LOT 1 PLAT OF SUB. OF
 ADLEY W. - MARY M. BROADWATER
 PLAT CMP 4977
 5TH DISTRICT HOWARD CO., MARYLAND
 SCALE: 1" = 100'

HINES RESIDENCE

5401 BROADWATER LANE
CLARKSVILLE, MD 21029

BP00140230

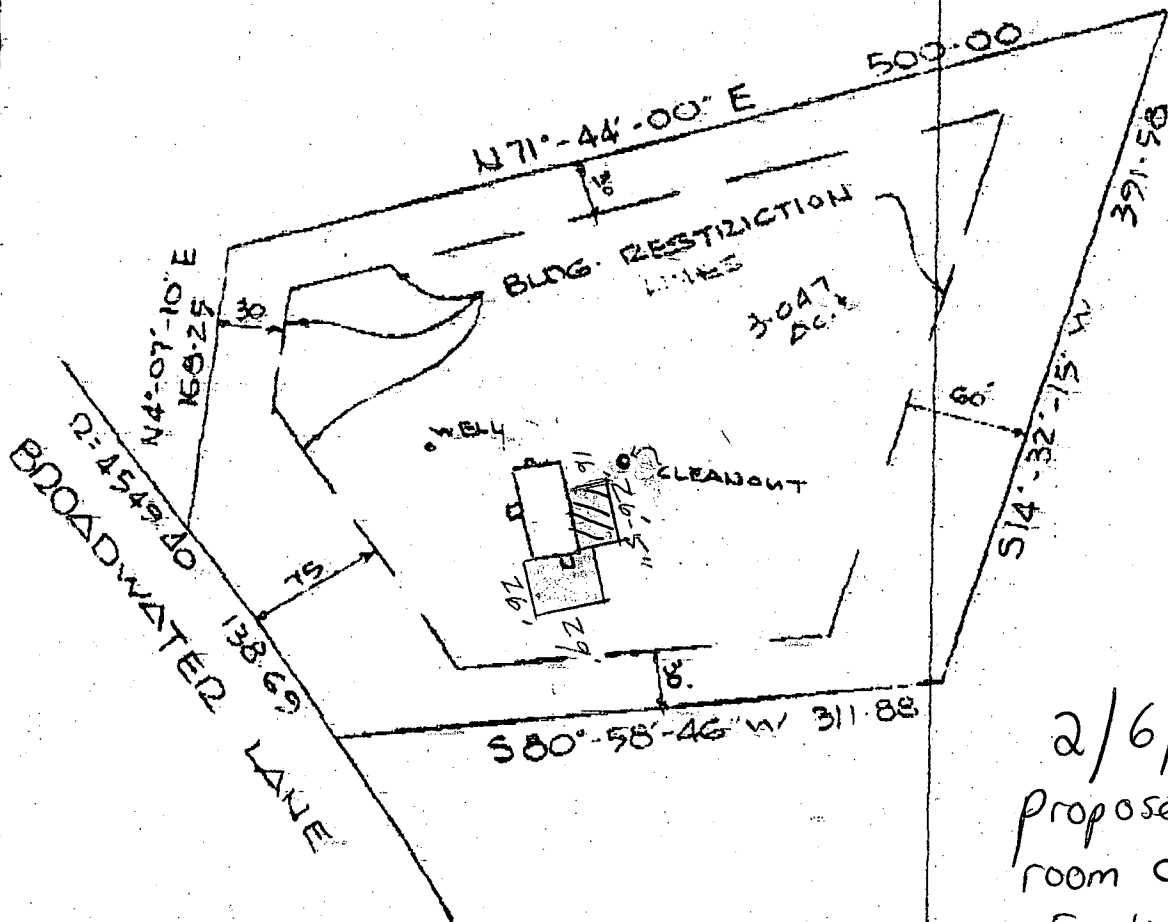
2/6/03-
 Proposed dining
 room OK (SRK)
 Existing foundation
 is 8'± to ex.
 septic tank

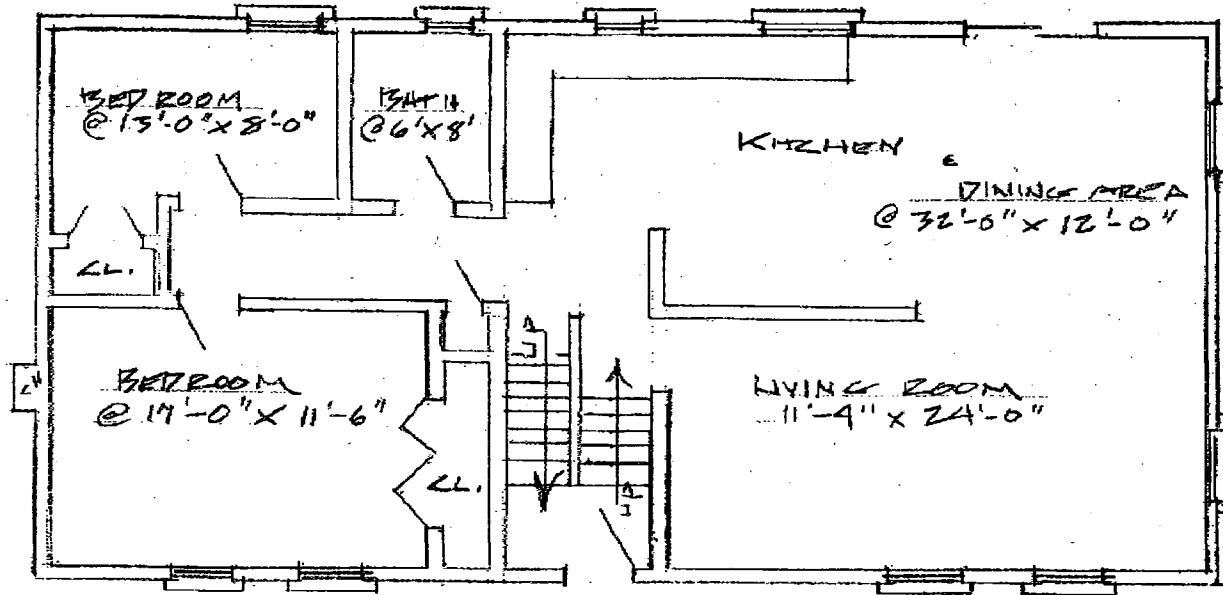
System already
sized for 3 bdrm
although only
2 bdrm. Told him
a repair may be
necessary in a
few years or
so depending on
water useage.

OK
